SAFETY ADVISORY # 16-261

Bullet and Passport AC Wiring

Fig. 1

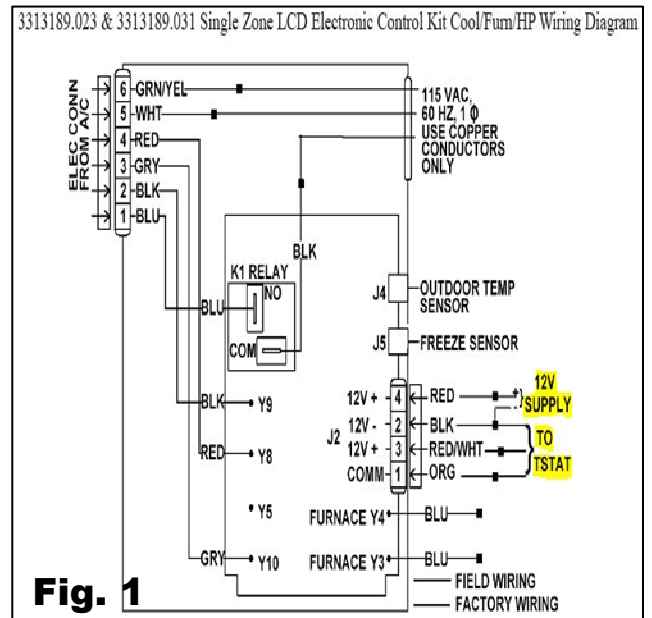
Verify the positive wiring connections at the control box for the air conditioner are correct as indicated in diagram, Fig. 1.

There are 2 wires coming from the air conditioner control box that have identification tags. The other two wires will be a 14 gauge positive wire and 22 gauge thermostat wire. The wires should be connected as shown in the wiring diagram, Fig. 1, and Fig. 3.

Fig. 2 - Incorrect

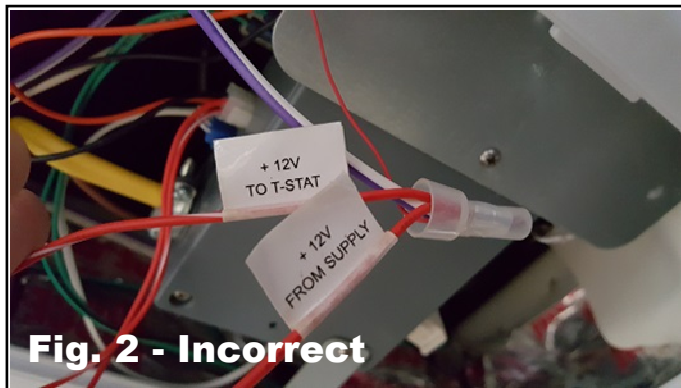
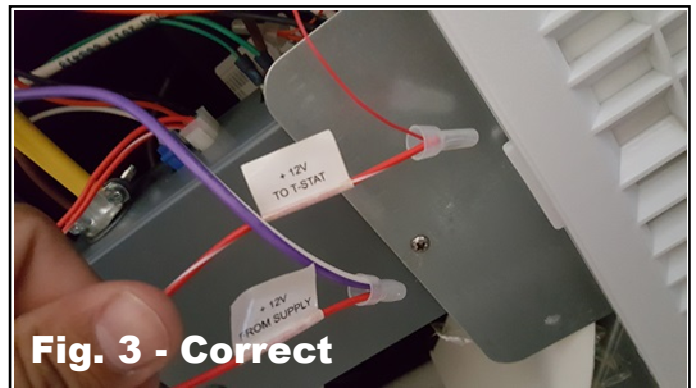
Keystone RV Company is conducting a voluntary RECALL notification campaign in accordance with the National Traffic and Motor Vehicle Safety Act. It has been decided the vehicles in this recall population may have wiring at the air conditioner that was not installed according to the air conditioner manufacturer's instructions. If the thermostat wires short together, there is an increased risk of damage or fire to the unit.

Remove bell cap or twist on connector where the positive wires that are tied together, Fig. 2, reconnect as indicated, Fig. 3.

Fig. 3 - Correct

Verify all connections are solid, no exposed bare wires.
